MI&CT ESERVICE NOTE SN07110612b

Subject: Hard Disk Drive Compatibility and Jumper configuration

Effectivity: ALL H1, H2, H3, GOC 1, GOC 2, and Lightspeed QX/I Consoles

2225004-8 Hard Drive

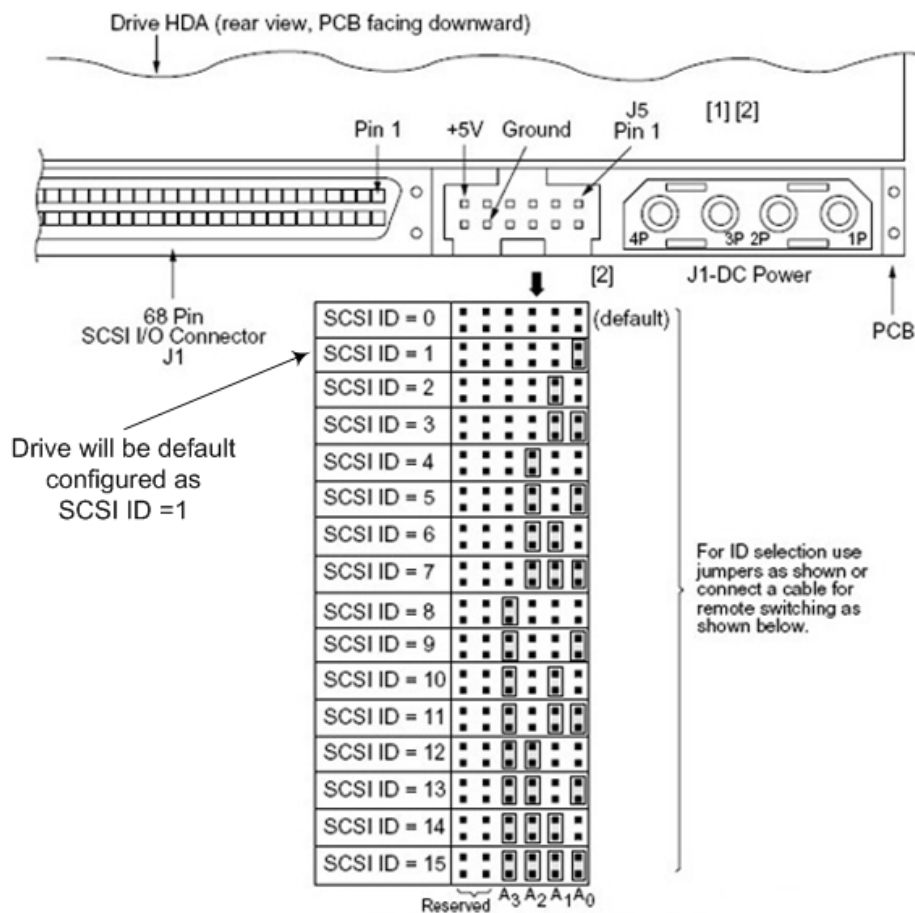
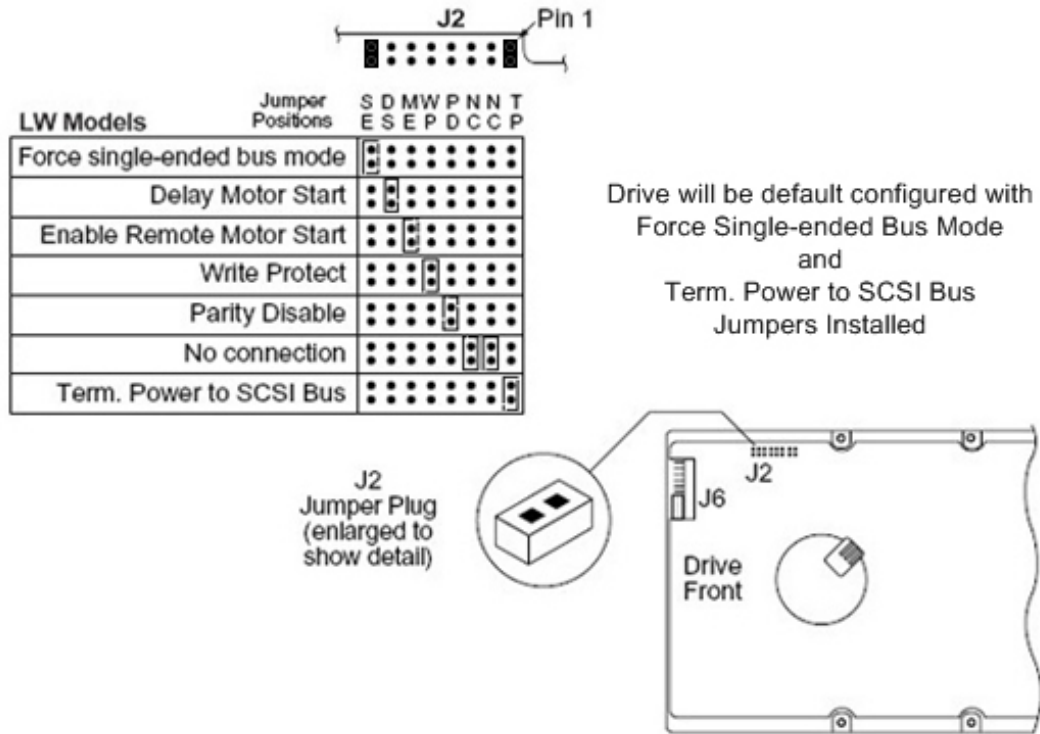
For reference information, here are pictures detailing the default settings and locations of the jumpers on the 2225004-9 and -10 hard disk drives as well as the current 2225004-8 hard disk drive.

2225004-9 & -10 Hard Drives

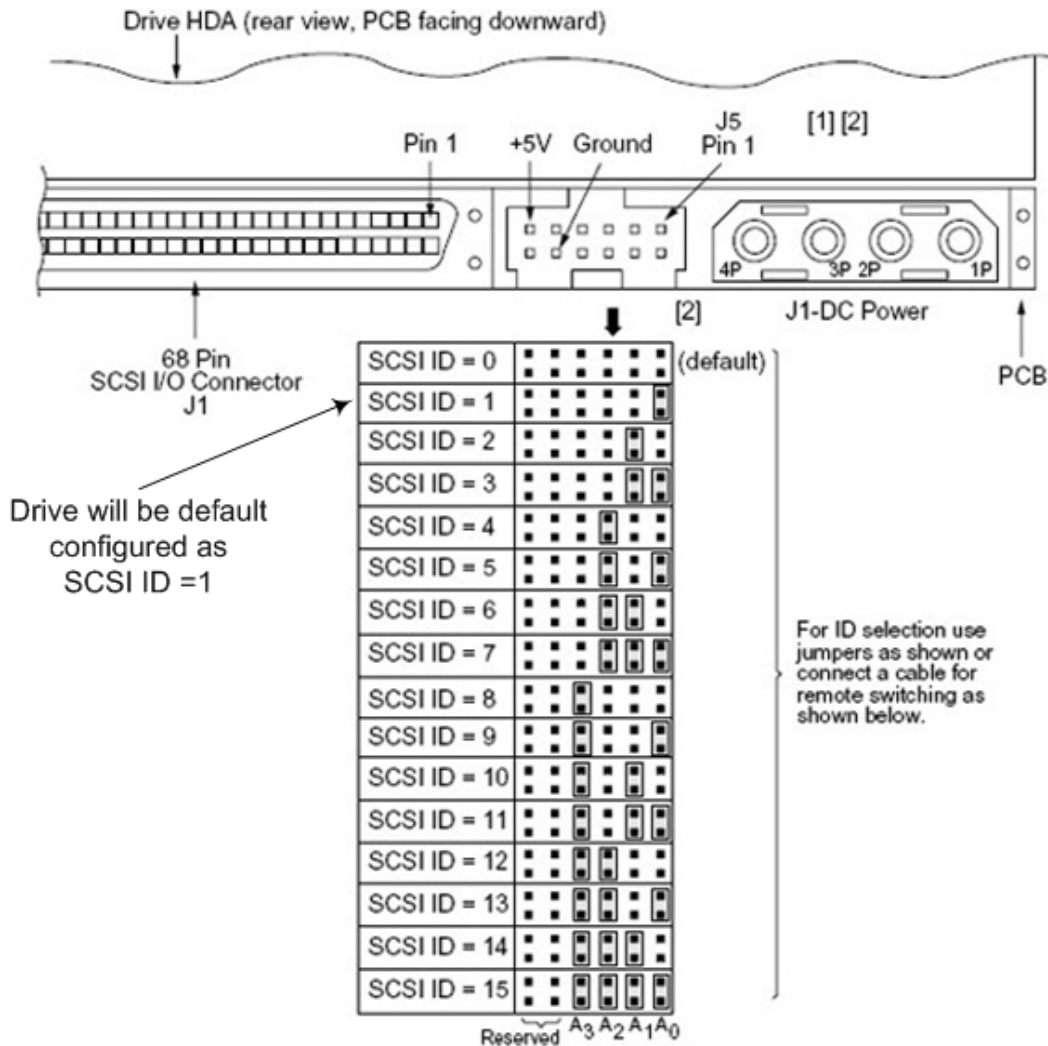
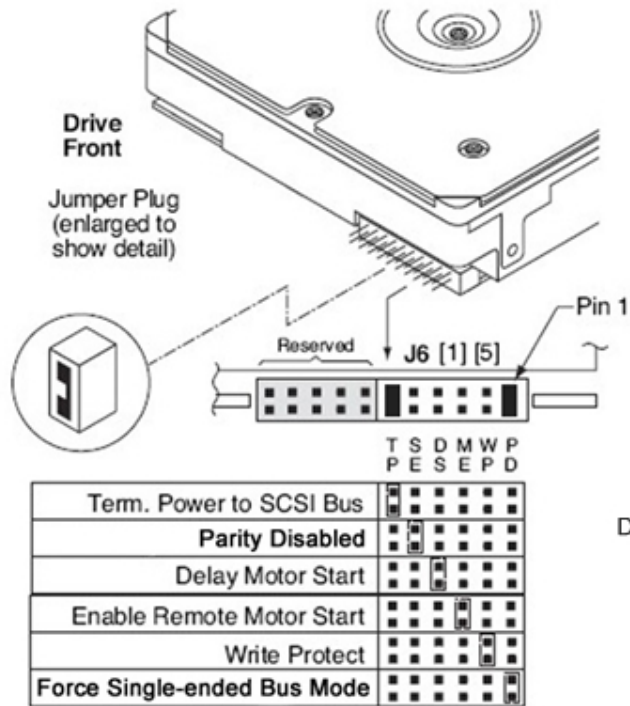
The 2225004-9 and -10 Scan Data hard disk drives are set up as a Field Replaceable Units and will come shipped with jumper settings correctly installed as *SCSI ID 1*, *Force Single Ended* and *Term Power On*. The jumpers will not need to be altered unless you are trying to install the drive in a 16-slice system. This system has two Scan Data Hard Drives. Thus, one must have SCSI ID 1 while the other drive must have SCSI ID 2. It does not matter which drive is ID 1 and which drive is ID 2.

NOTE: Depending on hardware configuration, some 16 Slice systems with dual Scan Disk Drives may require the removal of the Forced Single-ended Bus Mode jumper.

Drive will be default configured with
Force Single-ended Bus Mode
and
Term. Power to SCSI Bus
Jumpers Installed
